## SUBDIVISION REVIEW SHEET

**CASE NO.:** C8J-2022-0351.1A

**SUBDIVISION NAME:** Whisper Valley Multifamily Subdivision Parcel 3 and 4

### CITY OF AUSTIN – TRAVIS COUNTY – SINGLE SUBDIVISION OFFICE SUBDIVISION APPLICATION – MASTER COMMENT REPORT

Exhibit B: Proposed Plat

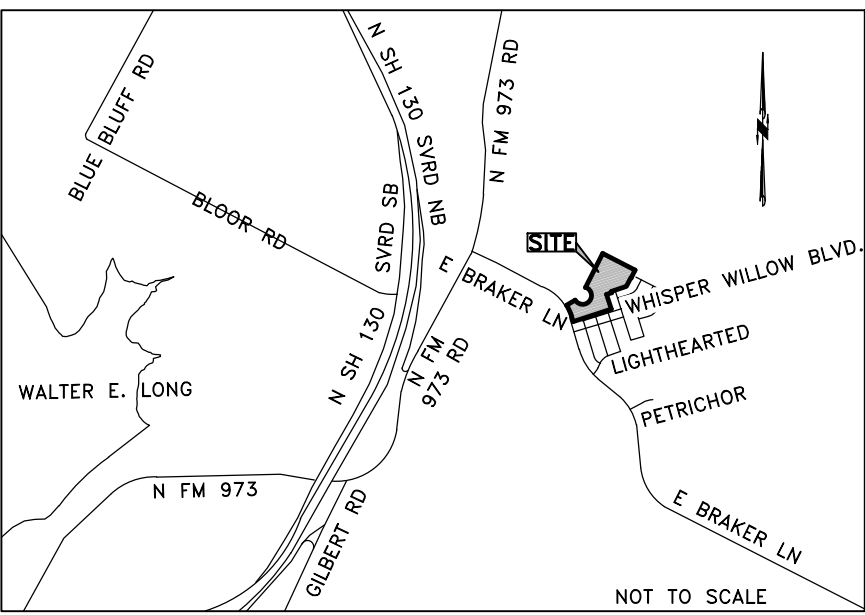
- SR4.** Move the text boxes for the lot area and ROW out of the plat diagram/ face of the plat (30-1-113)

- SR5.** Remove the text for the deed property description in both lots on the face of the plat/ plat diagram (30-1-113)
- SR6.** Please provide copies of all recorded easements (30-1-113)

- SR7.** Note 23 is saying that there will be a 10 ft utility easement on all lots, but this does not appear on the face of the plat/ plat diagram? Why? Please show all current and proposed easements on the face of the plat (30-1-113)

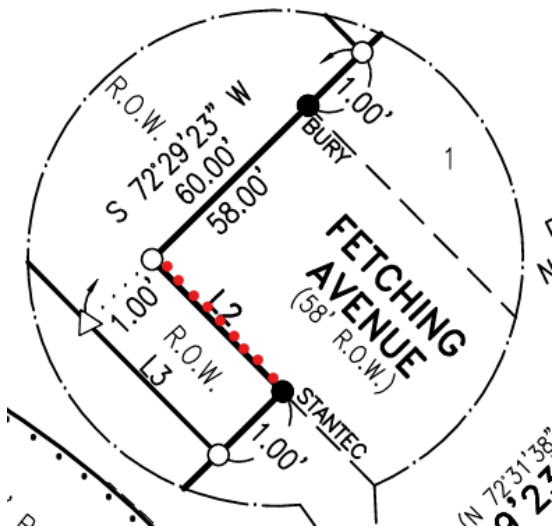
**ATD 2.** Continue a dotted (sidewalk) line in the following location:
